SPRINGDALE SOLAR FARM

Further Request for Information (RFI) Report

Author	Steven Reid
Date	1 st October 2020
Ref	04317-1602908

CONSTRAINTS AND
LAYOUT PLAN
- AMENDMENTS

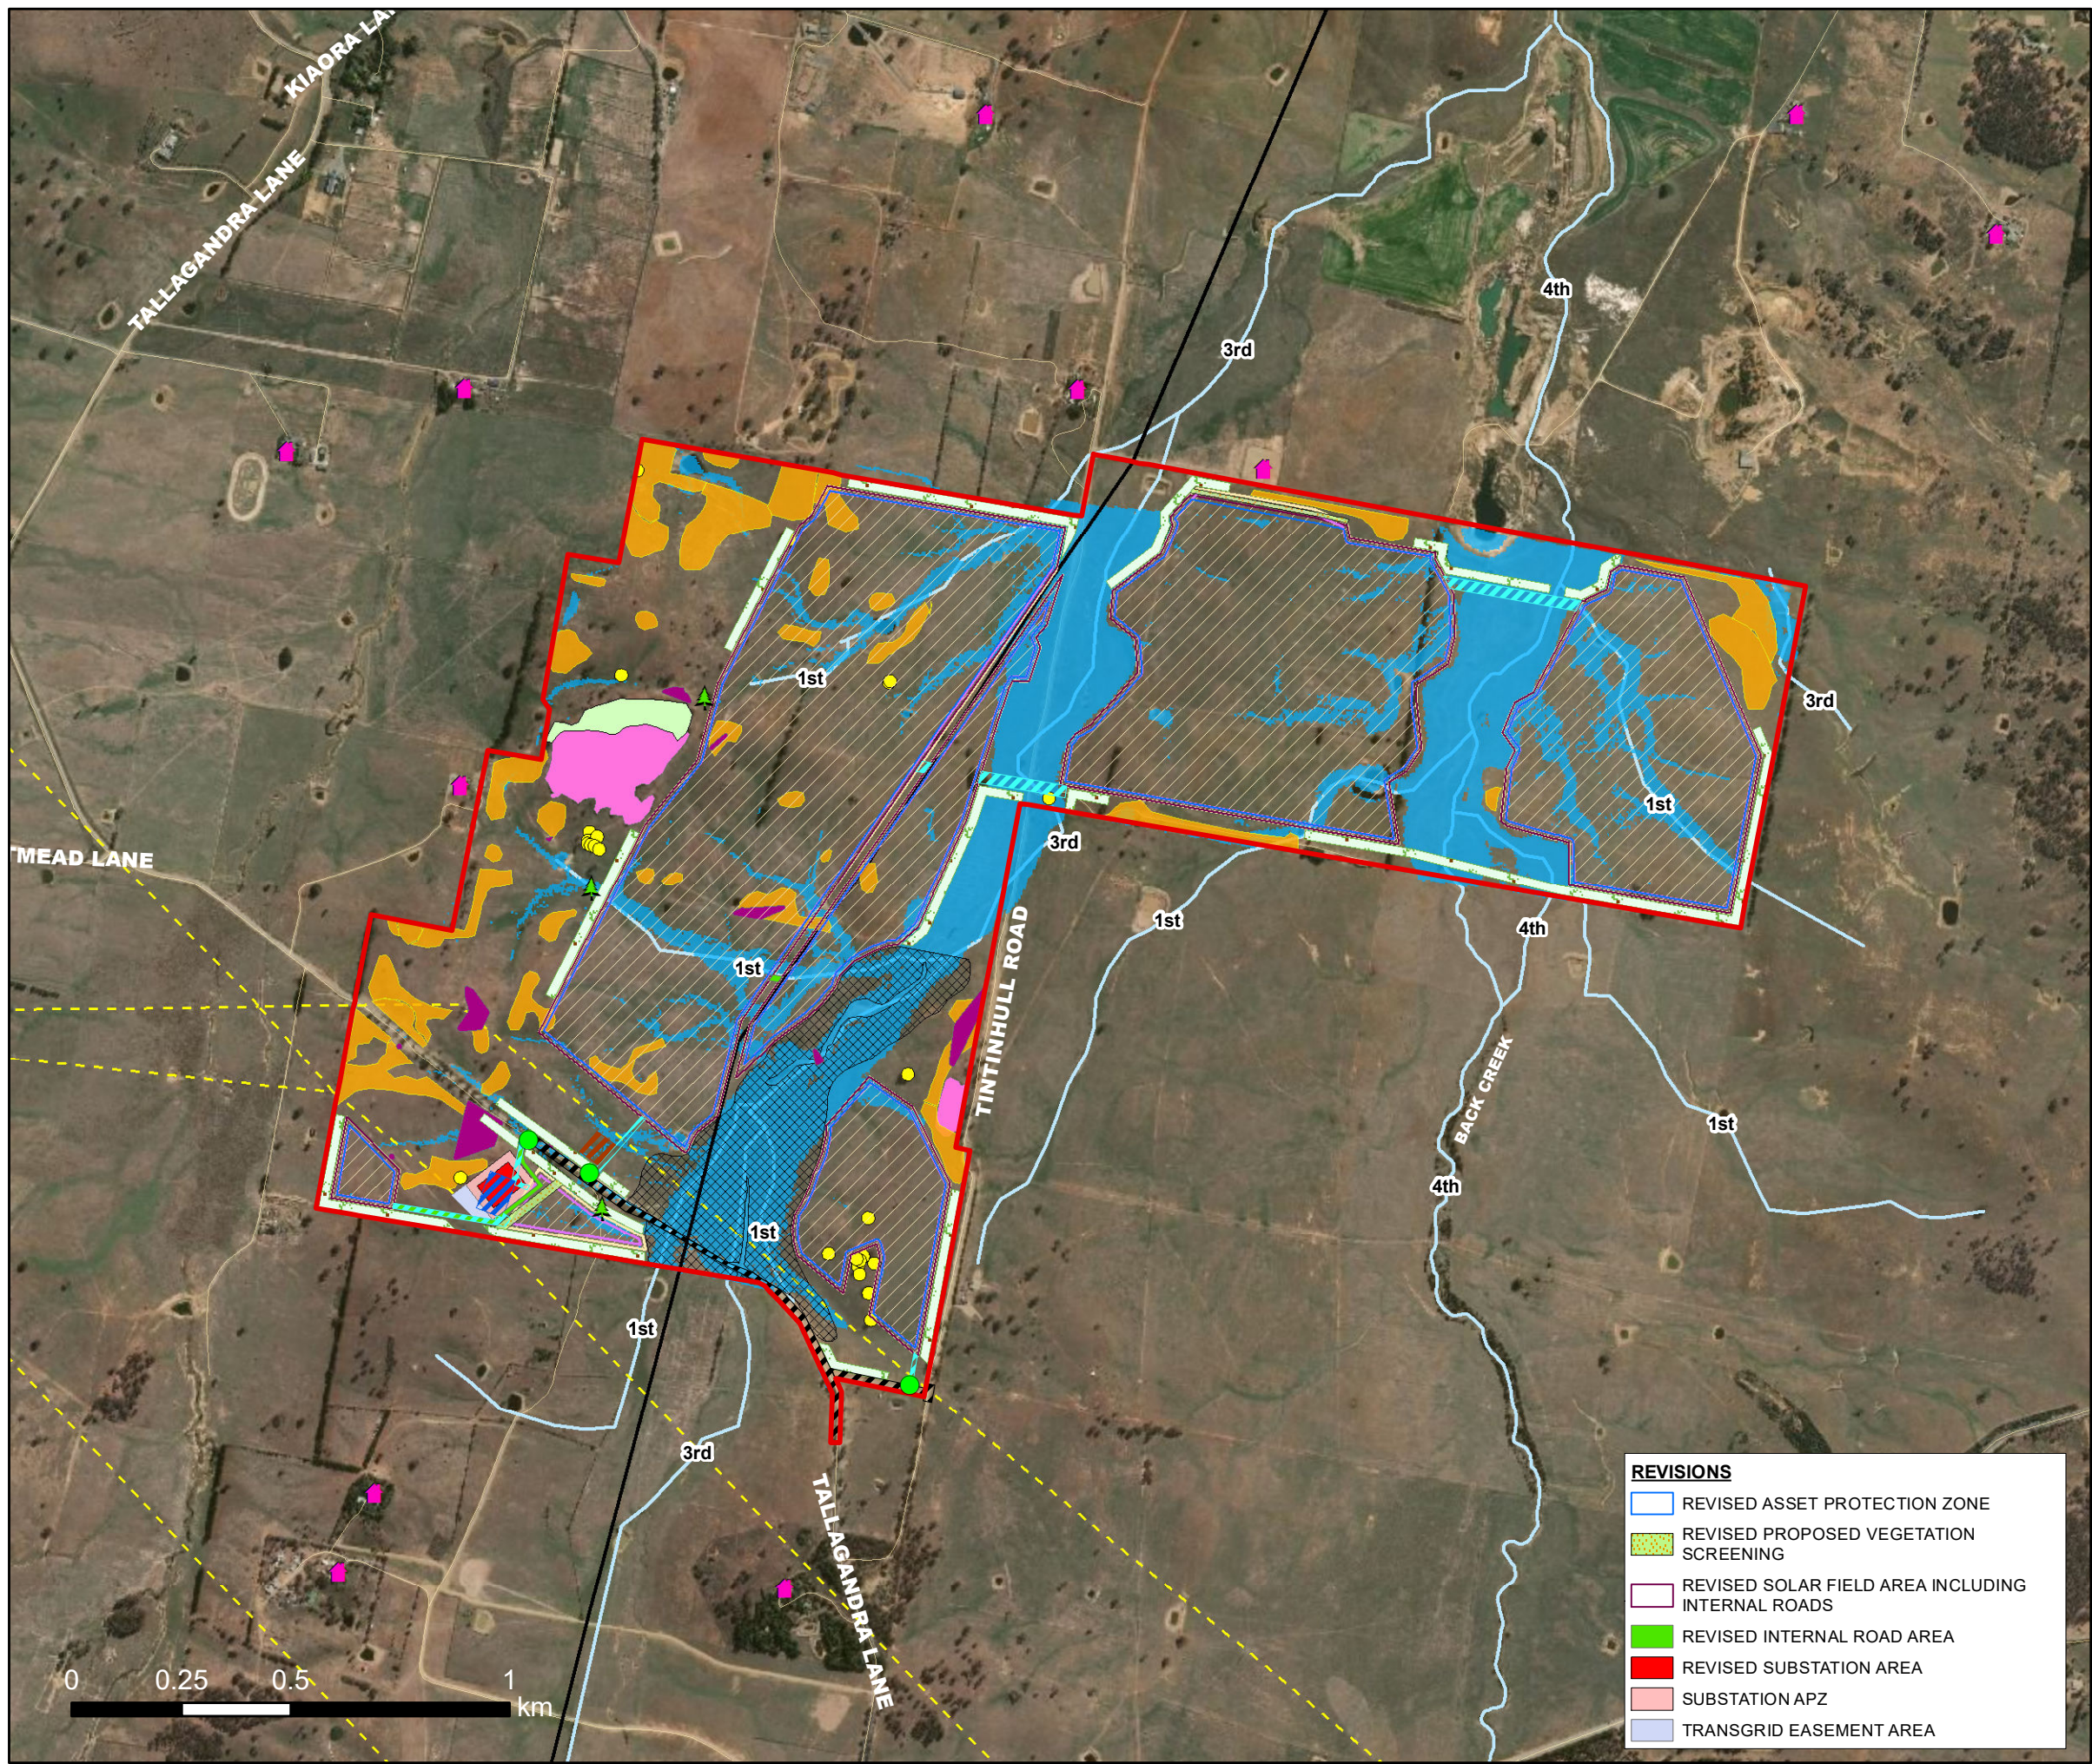
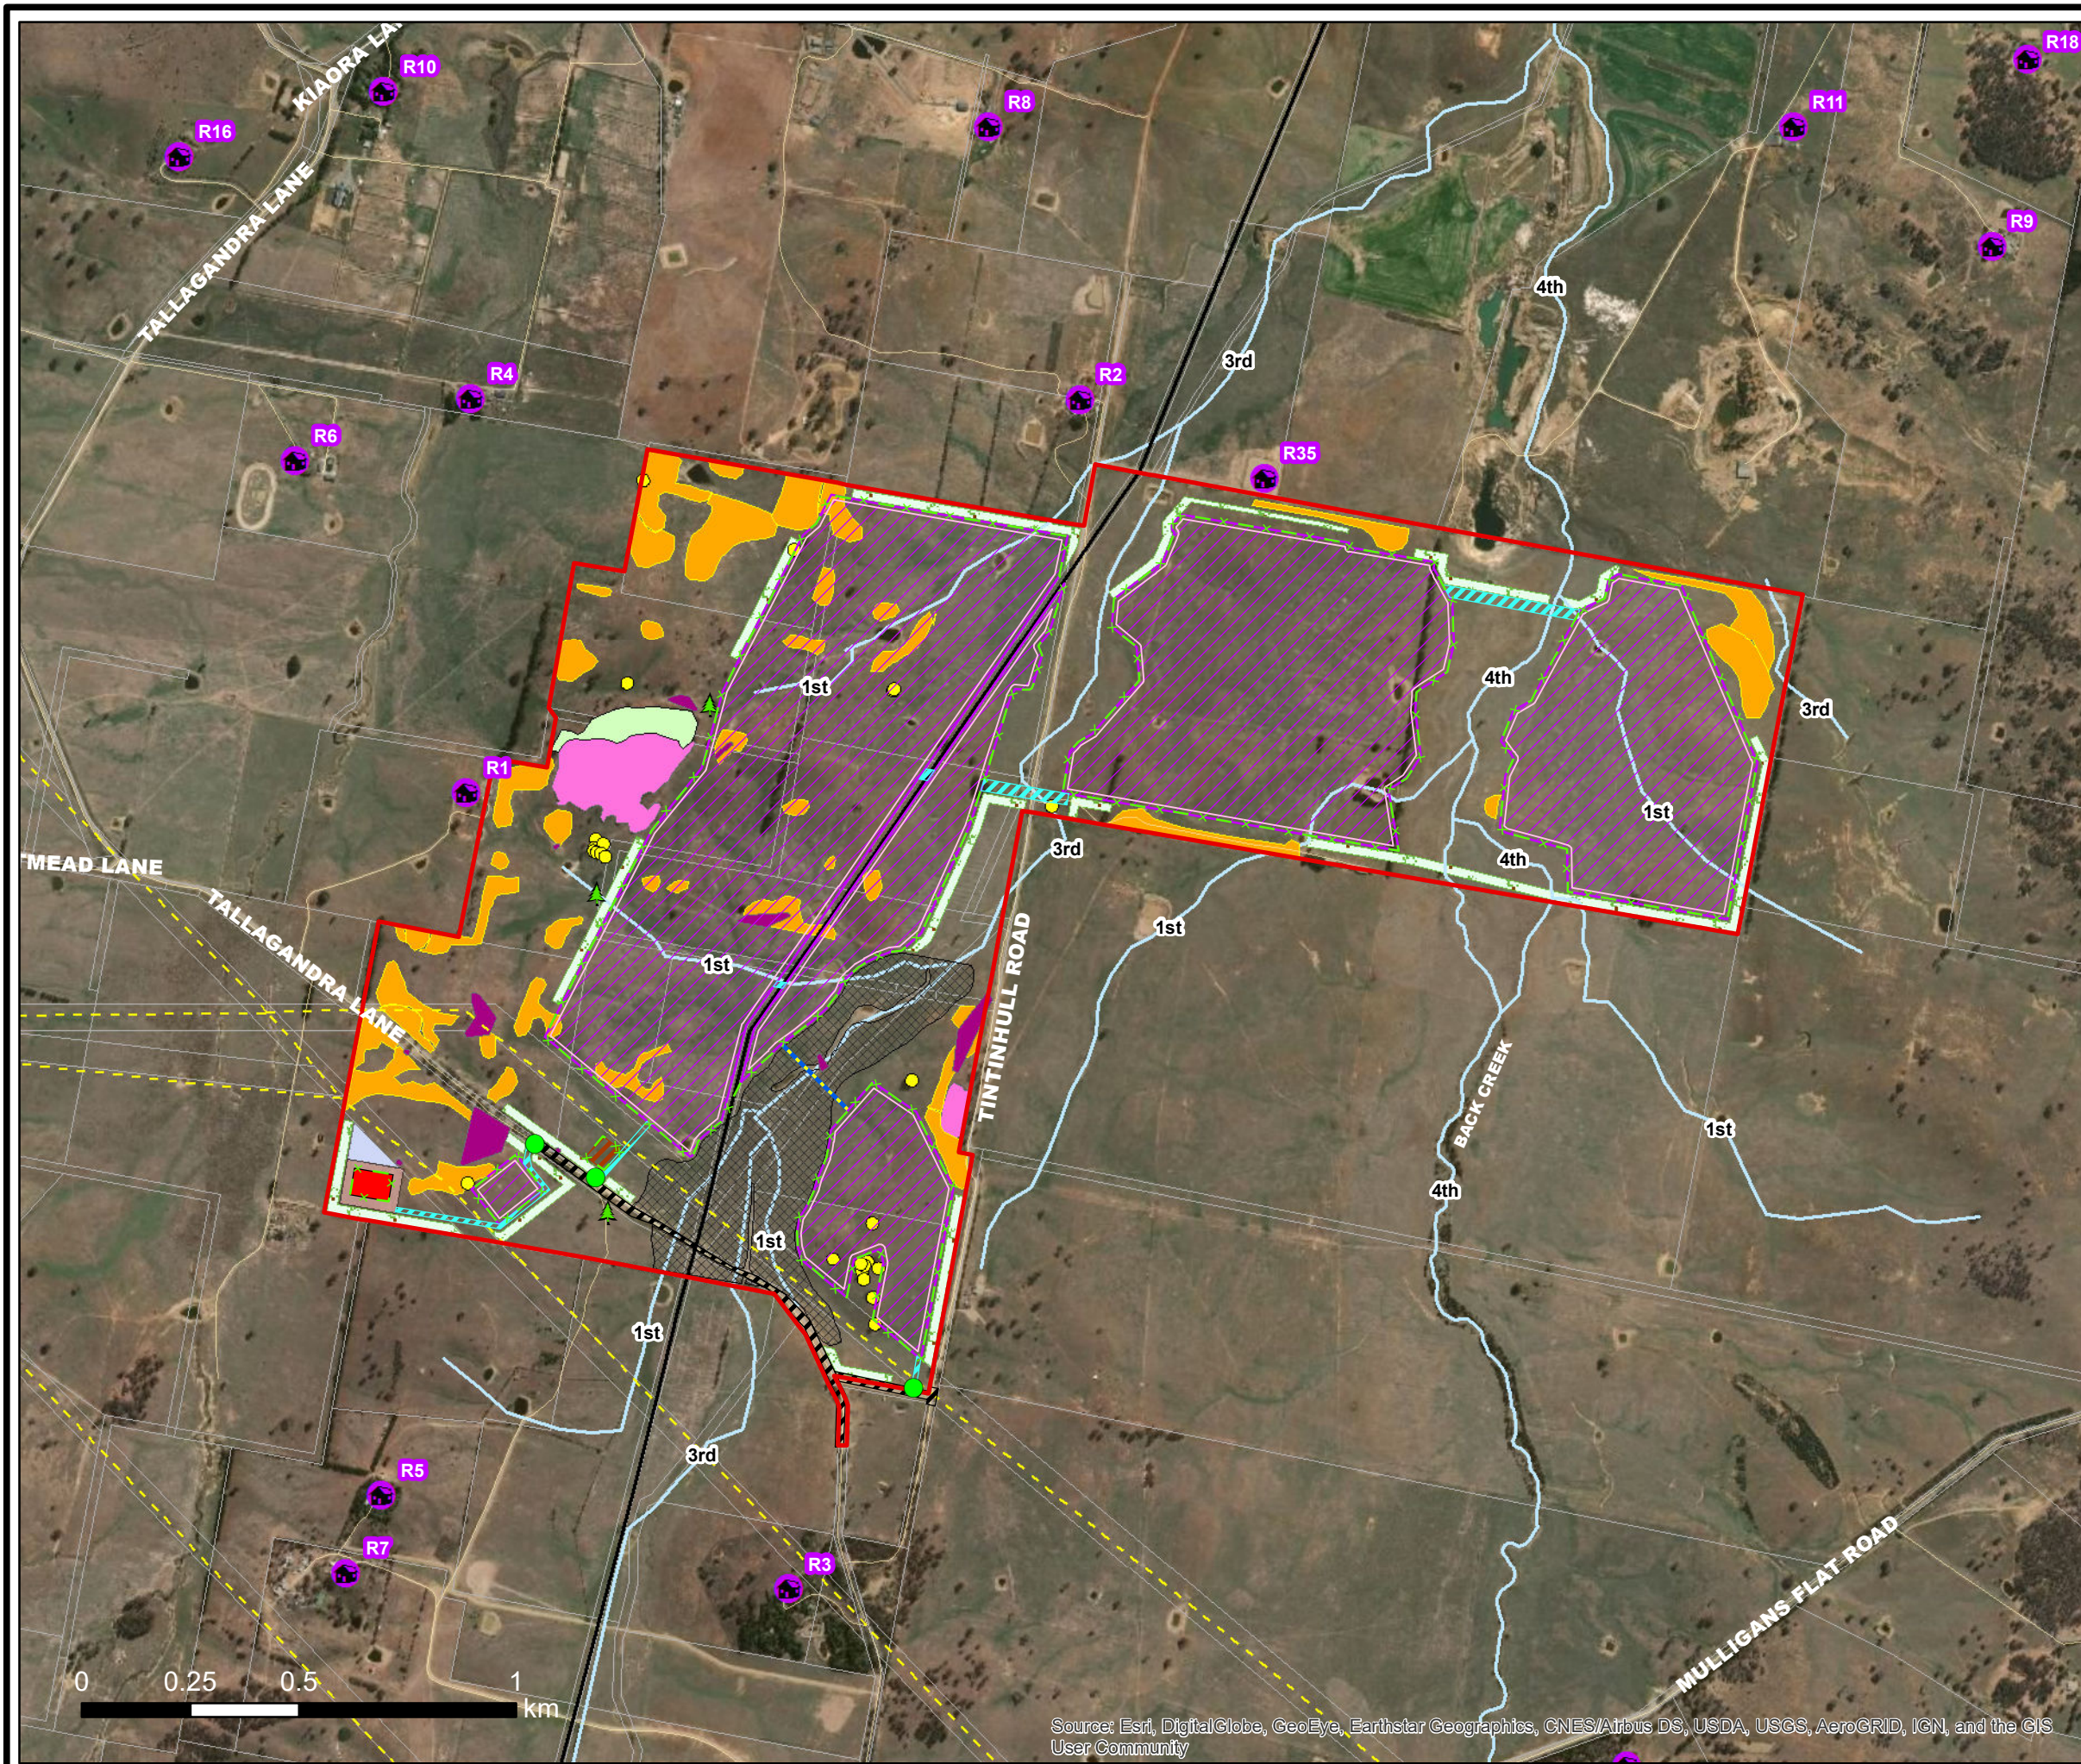
Provide viewsheds from R1, R2, R5 and new dwelling, and confirmation that the Visual Envelope Map in the LVIA is modelled based on topography alone, and not taking intervening vegetation into consideration;	<p>AECOM have confirmed that Figure 2 (Visual envelope map) within the Landscape and Visual Addendum is a zone of theoretical visibility (ZTV) of the project taken at 1.7 metre eye height, with a 2 km range from the perimeter of the solar farm applied. That is, areas that are not shaded on the map are either outside the 2 km buffer or have their view of the solar farm obstructed by the natural topography (from an eye height of 1.7 m). Screening by intervening vegetation was not considered when preparing this map.</p> <p>Viewsheds have been provided for all 4 requested receptors and are included at Annexure B</p>
Updates to the Main Constraints map:	
Label residences as per Noise Impact Assessment numbering (eg Gillett is R1, Hassall is R2 etc);	Completed, see revised Constraints plan at Annexure C.

Add security fencing layer;	Completed, see revised Constraints plan at Annexure C.
Remove 1 in 100 year flood profile layer;	Completed, see revised Constraints plan at Annexure C.
<p>Correct the stream orders and confirm adequate buffer distance on the map (can be done via a text box if easier than in the Legend):</p> <p>Back Creek is 4th order stream; and the unnamed creek is 3rd order stream;</p>	<p>Completed, see revised Constraints plan at Annexure C. The amended stream orders are consistent with Water Management (General) Regulation 2018 Hydro Line spatial data, which is used to determine the Strahler stream order.</p> <p>The Project has been developed with a view to maintaining appropriate buffers to all relevant environmental constraints, including waterways. It is noted that, as the Project is SSD, the requirement for an activity approval under section 91 of the Water Management Act 2000 does not apply. This is by virtue of section 4.41 of the Environmental Planning and Assessment Act 1979, which specifies certain authorisations which do not apply to SSD. Following this the Natural Resources Access Regulator's Guidelines for controlled activities on waterfront land also does not apply. Despite this, the proponent has worked to avoid sensitive riparian areas, particularly those associated with potential threatened species habitat, such as Striped Legless Lizard Habitat within the southern portion of the site.</p>

Confirm how the SE array section would connect to the substation;	The SE array will utilise directional drilling or an OHL avoiding the SLL habitat. This has been updated on the final layout plan at Annexure C.
Confirm the size of the final development footprint;	<p>Final development footprint, including Development Area, tracks, control room and substation is 185Ha.</p> <p>The current optimised layout is based upon 257,634 modules. This is an approximation and the final detailed design will confirm the number of panels to be used.</p>
Clarify traffic movements of OMOD, heavy and light vehicles during construction, and heavy and light vehicles during operation. Noting that a traffic movement is considered entering and exiting; and	<p>The EIS states the following:</p> <p>Construction: 75 daily heavy vehicle movements, 400 daily light vehicle movements and approximately 16 oversized vehicles. It also notes these numbers are based on a single vehicle movement either entering or exiting the site. Considering this, we continue to support the proposed heavy vehicle and light vehicle numbers for the construction period. Converted to the anticipated definition of 1 vehicle movement equating to the vehicle entering and existing site. The numbers would be defined as; 38 daily heavy vehicles movements and 200 daily light vehicle movements. We consider the oversized vehicle movements to be overstated and would propose a change to 3 oversized vehicle movements during construction.</p> <p>Operations: 10 daily light vehicles movements during the first 2 years. Water trucks will be required for panel cleaning when there is less rainfall. This could equate to between 2-3 water trucks per week over the course of a year.</p>

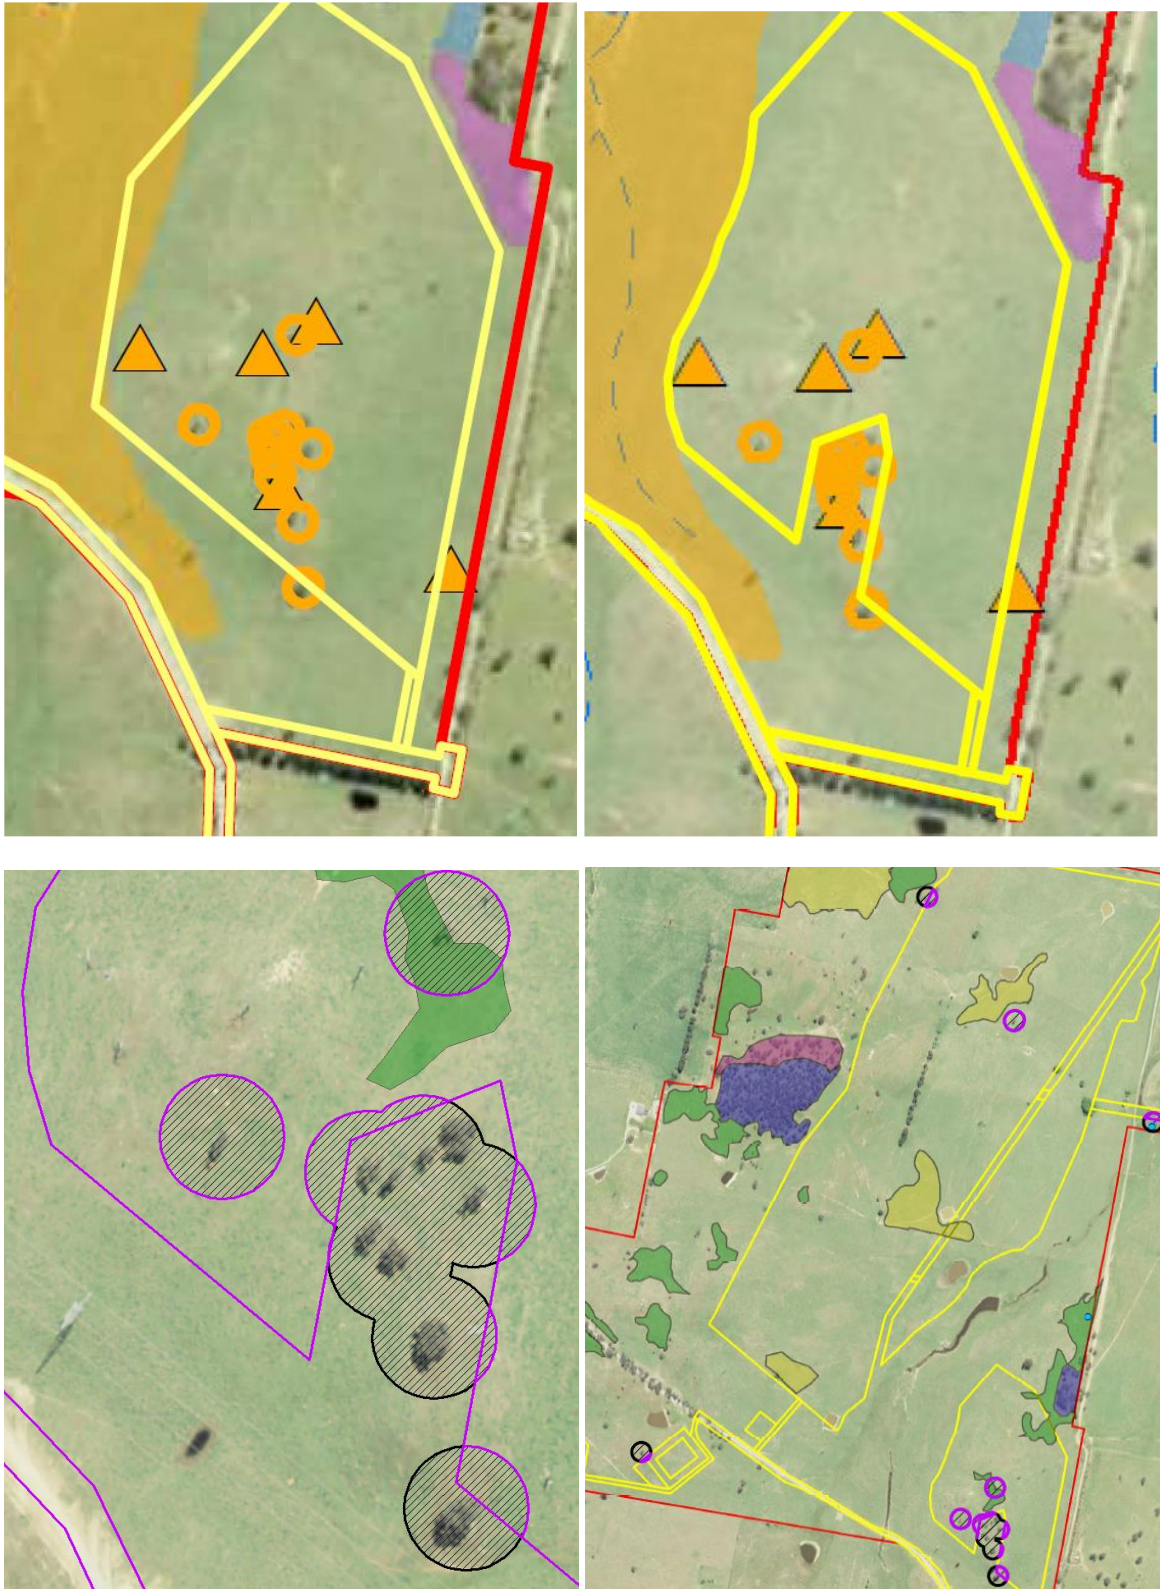
There is a stand of hollow bearing Eucalyptus mannifera (Brittle gum) in the south-east corner of the site, adjacent to Tintinhull Road, as shown in Figure 6 of the BDAR. This area is suitable Superb parrot breeding habitat and should be avoided or offset using the Biodiversity Assessment Method. If the trees are retained, the BMP should include actions to protect them in the long term such as excluding grazing to promote tree regeneration.

The OEH submission (2018) noted that *E. mannifera* had been proven to be a candidate breeding tree for Superb Parrot and that the *stand of hollow bearing Eucalyptus mannifera (Brittle gum) in the south-east corner of the site, adjacent to Tintinhull Road, as shown in Figure 6 of the BDAR* should be avoided due to potential breeding habitat or offset (see Plate 1).

In response, the design footprint was amended to avoid the referred-to trees, as stated within the updated BDAR (June 2020), and the offset of 0.25 ha was maintained for impacts to remaining trees within the development area. The BCD reviewed the amended design (June 2020 correspondence) and sought additional protection or offsetting for trees to be cleared or that are adjacent to the development footprint.

Based on these changes the Superb Parrot species polygon has been revised from 0.25 ha to 0.94 ha.
